MSO9064A-03

S E R V I C E N O T E

MSO9064A Oscilloscope: 600MHz, 4 analog channels

Figure #1.

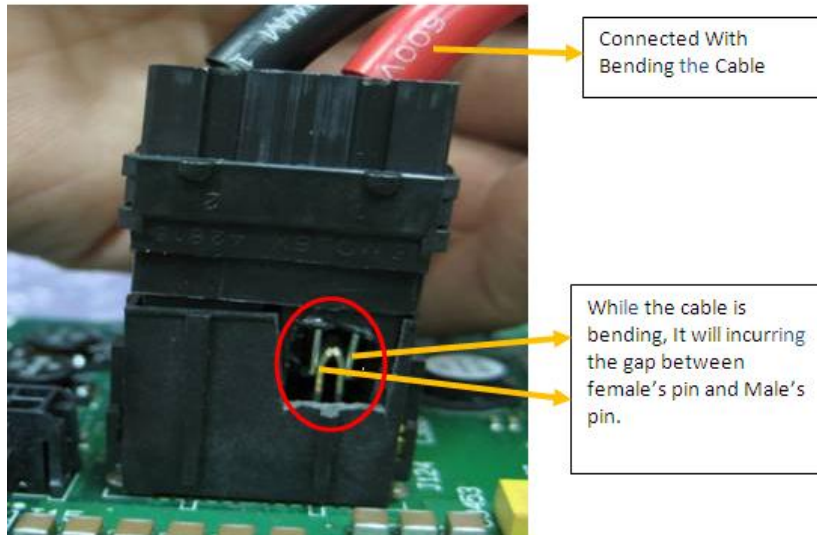
Many customers are experiencing Random Shutdowns. This make them want to have Service Note - 02A completed. The problem is with service note -02A, this isn't the only possible cause for the symptom consequently not resolving their problems. This issue has been determined to be a connection problem with the J124 connector on the acquisition assembly and the 12 volt power cable. See figure #1.

Replace the 12 Volt Bulk power cable to the longer version 54904-61631 eliminating the connector tilt increasing the surface tension. See Figure #2. Clean and inspect the connection J124 on the acquisition board. If the J124 is pitted then replace the acquisition board. Use contact cleaner or alcohol.
